STAFF RECOMMENDATION

1021 Russell Street

August 18, 2021

Application: New Construction—Infill; Partial Demolition

Figure 5. 1021 Russell St, March 2016, Google maps. Figure 6. Proposed tower.

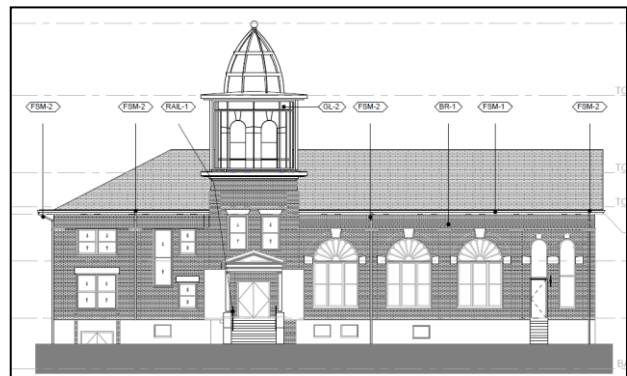
The preservation permit did not include the reconstruction of the tower, which is now proposed with this application. The applicant proposes to reconstruct the tower with the same dimensions as what was there originally, but the proposes to use metal and insulated frosted glass (Figures 5-6) as a contemporary version of what was lost.

While replacing historic materials does not meet the guidelines, the historic materials are no longer present due to circumstances beyond the owner’s control. Staff finds that

reconstructing the tower at the same scale but with contemporary materials can meet Section III.B.1 of the design guidelines since the tower is a character-defining feature.

SITE PLAN

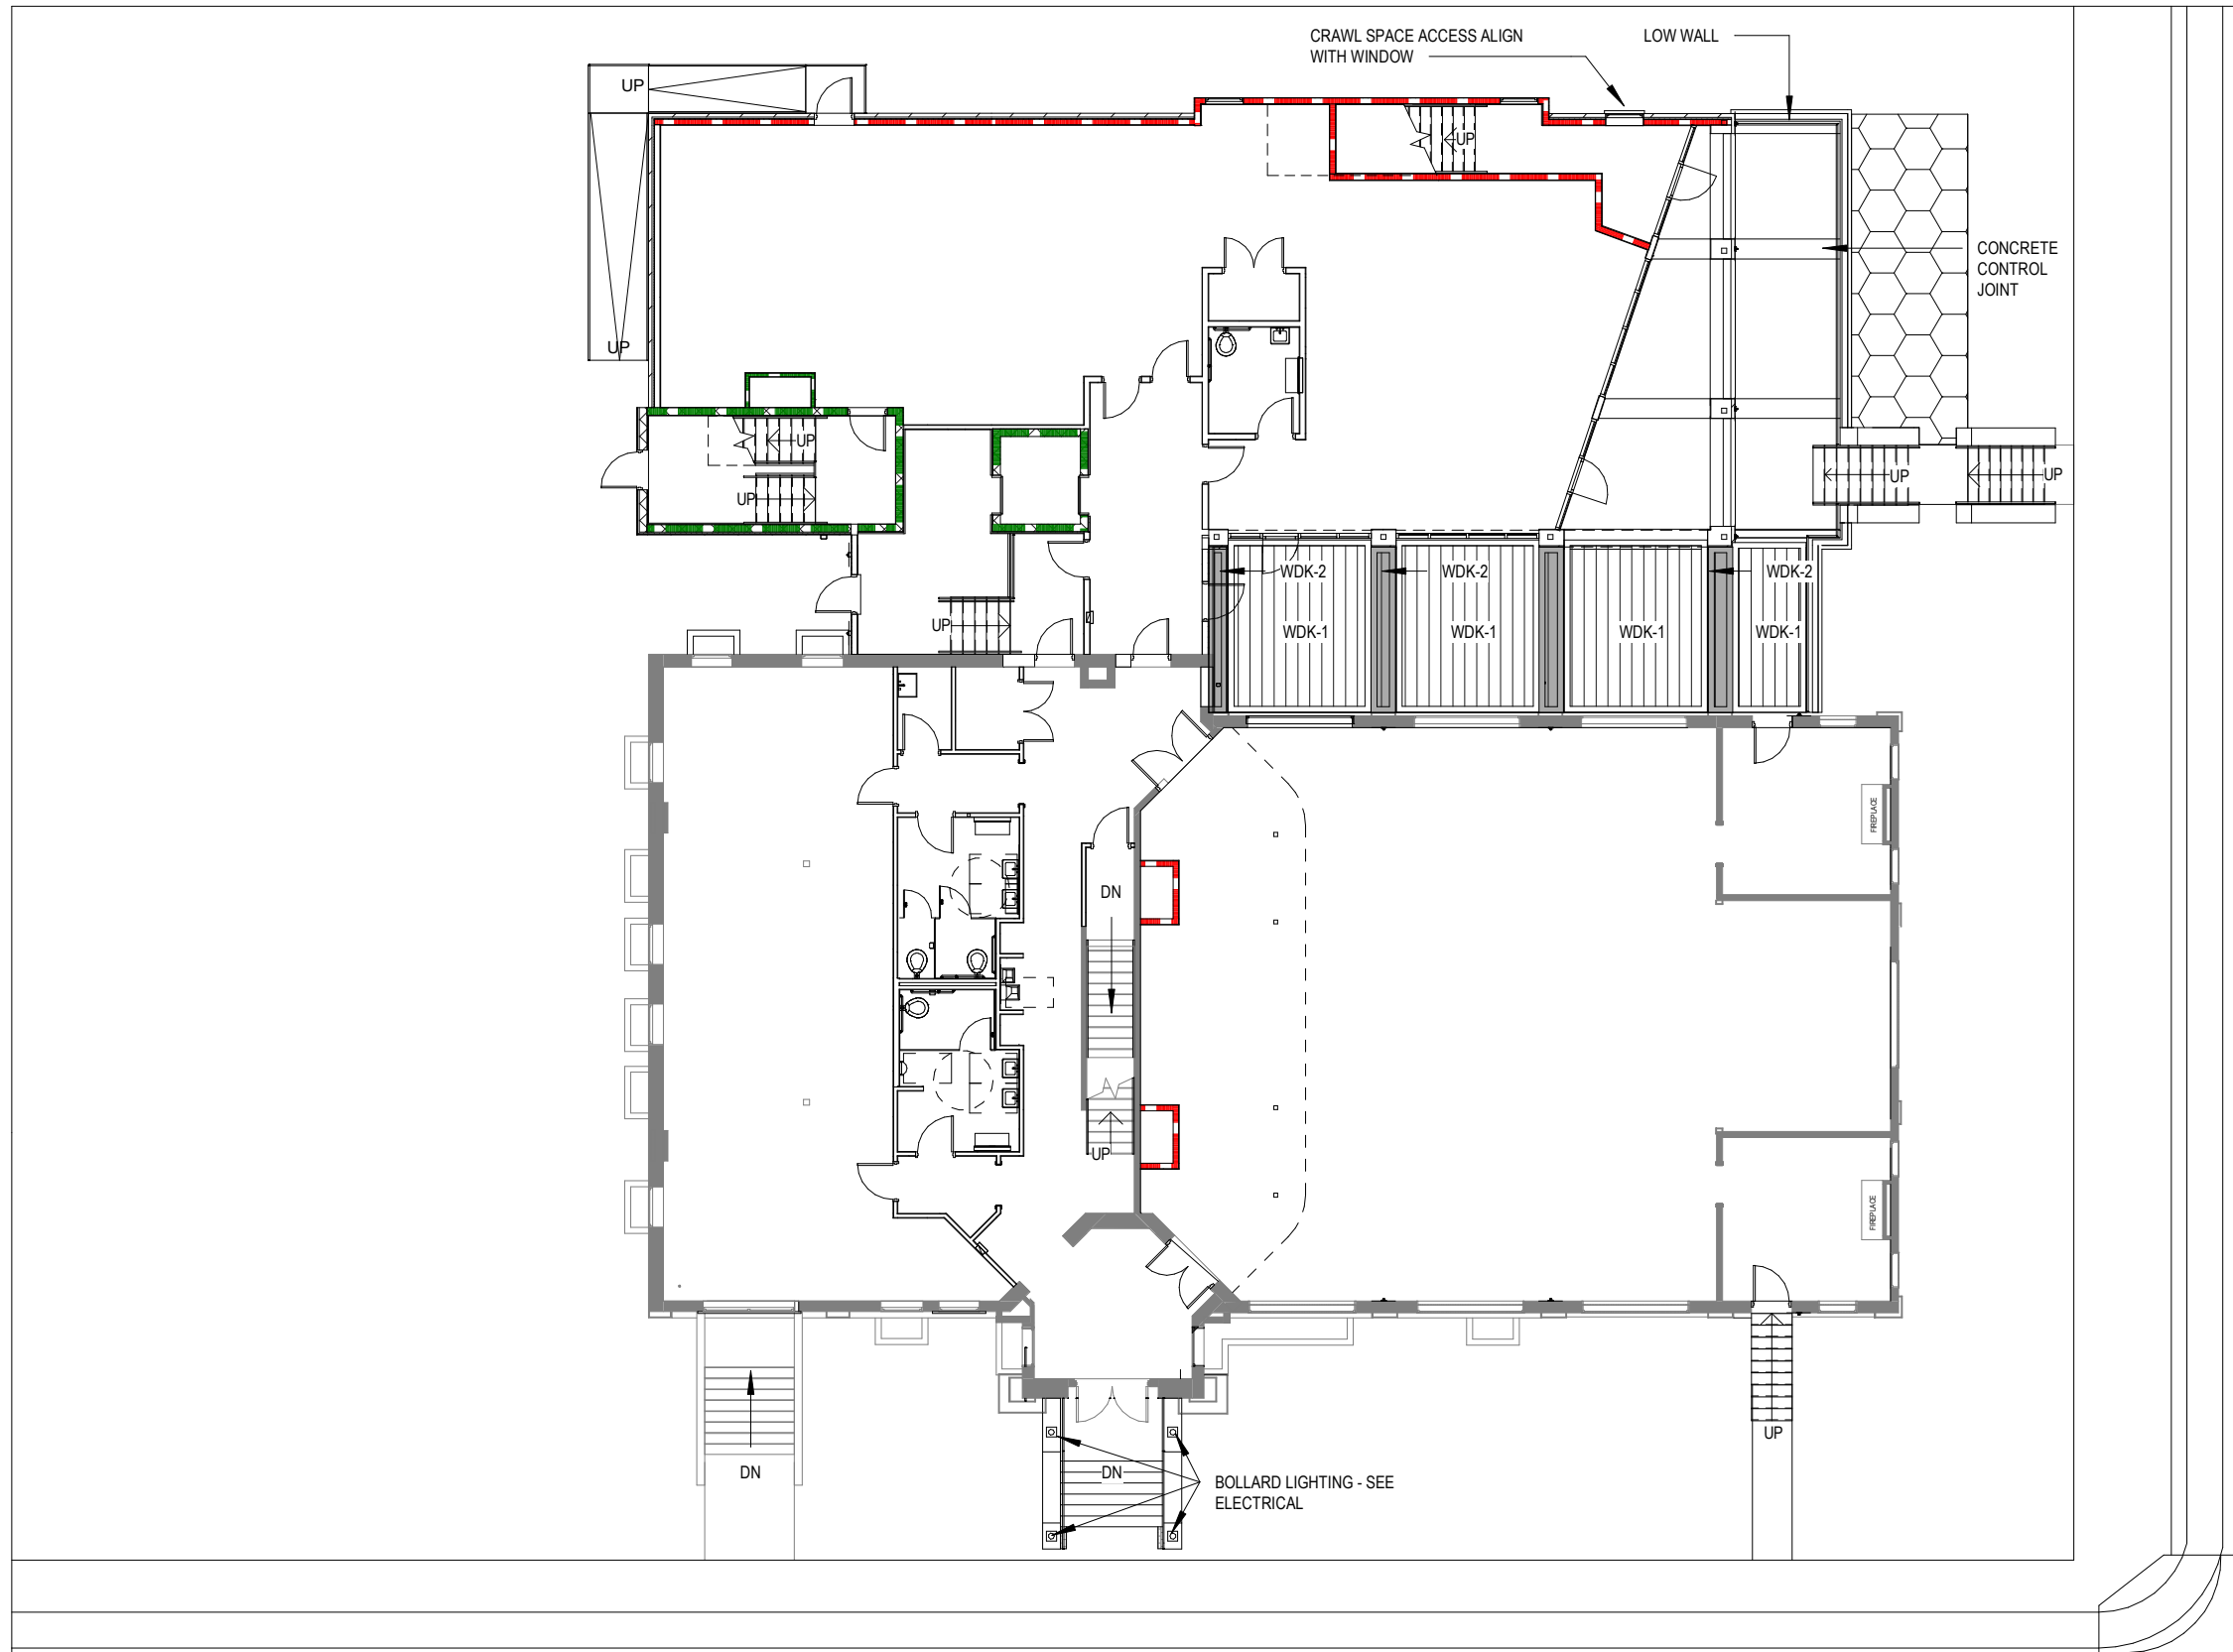
1. The finished floor height shall be consistent with the finished floor heights of the adjacent historic houses, to be verified by MHZC staff in the field;
2. Staff approve the final details, dimensions and materials of foundation material, trim, windows, doors, trim, porch floors and railings, walkway material, and retaining wall material; and,
3. Staff approve the roof color and masonry color, dimensions and texture.
